Item ID: D212-664-101TRN

Item Name: Crosstube Turning Detail

DART AEROSPACE LTD		Work Order:	108697
Description: Crosstube Assembly (205/212/412 High Fwd)		Part Number:	D212-664-141
Inspection Dwg: D212-664-141 Rev: D		Page 1 of 2

DRAWING NO. D212-664-141	TITLE XTUBE ASSY (205/212/412 HI FWD)	REV. D	DART AEROSPACE LTD ENGINEERING ORDER		D.E.O. NO. D212-664-141-D-1	SHEET NO. SHEET 1 OF 2	SCALE NTS
DRAWN	CHECKED	MP	MFG. APPR.	APPROVED	MP	DE APPR.	
DATE 11.04.07	DATE 11.07.11		DATE 11.04.12	DATE 11/09/12		DATE 11.04.12

**D212-664-141/-141B
ASSEMBLY DETAIL**

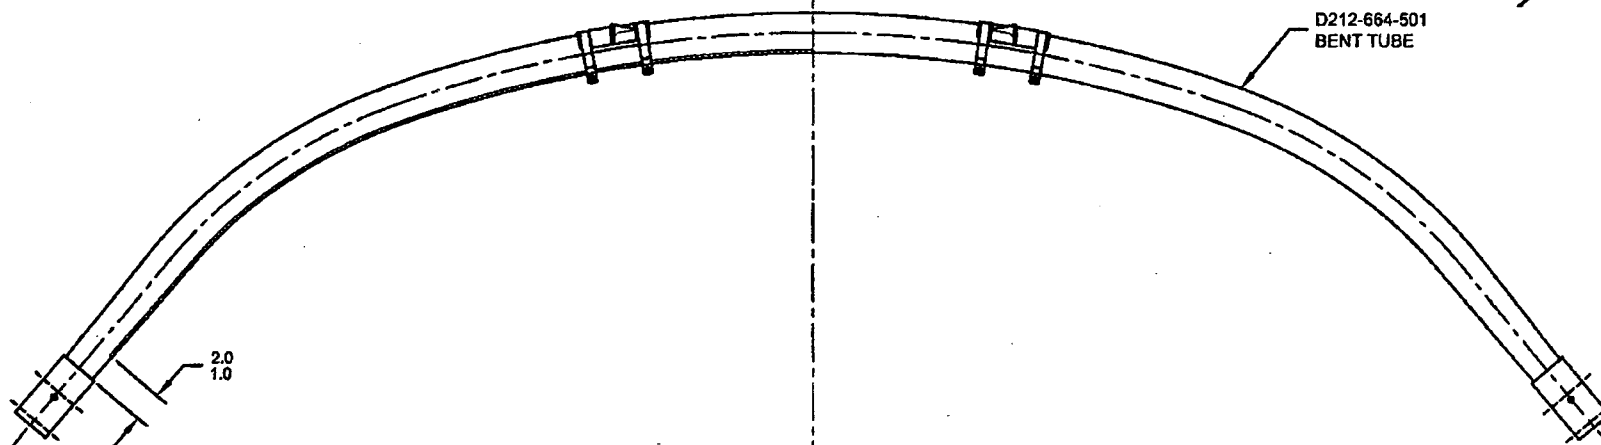
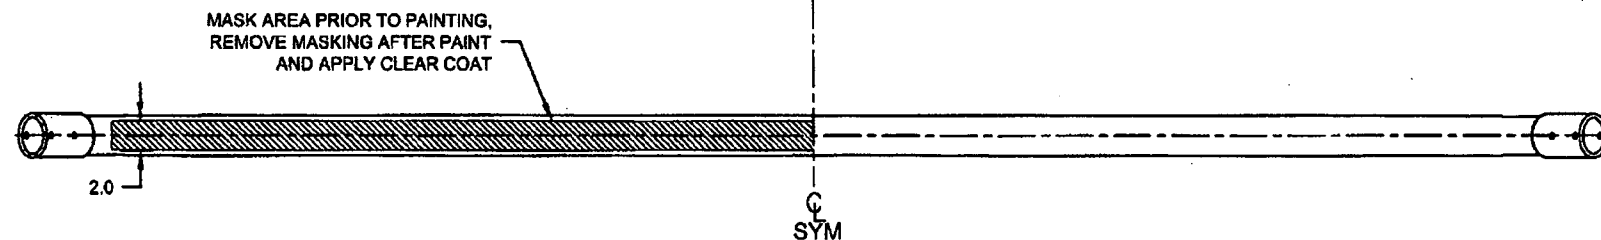
PURPOSE:

ADD AN INSPECTION WINDOW TO UNDERSIDE OF CROSSTUBE.

NOTES 2 OF SHEET 1 IS AMENDED AS FOLLOWS:

IS:

WAS:

- 2) FINISH: CHEMICAL CONVERSION COAT PER DART QSI 005 4.1
PRIME INSIDE AND OUTSIDE PER DART QSI 005 4.2
MASK UNDERSIDE OF CROSSTUBE AS SHOWN (HATCHED AREA) AND
PAINT OUTSIDE PER DART QSI 005 4.2
REMOVE MASKING AND APPLY CLEAR COAT
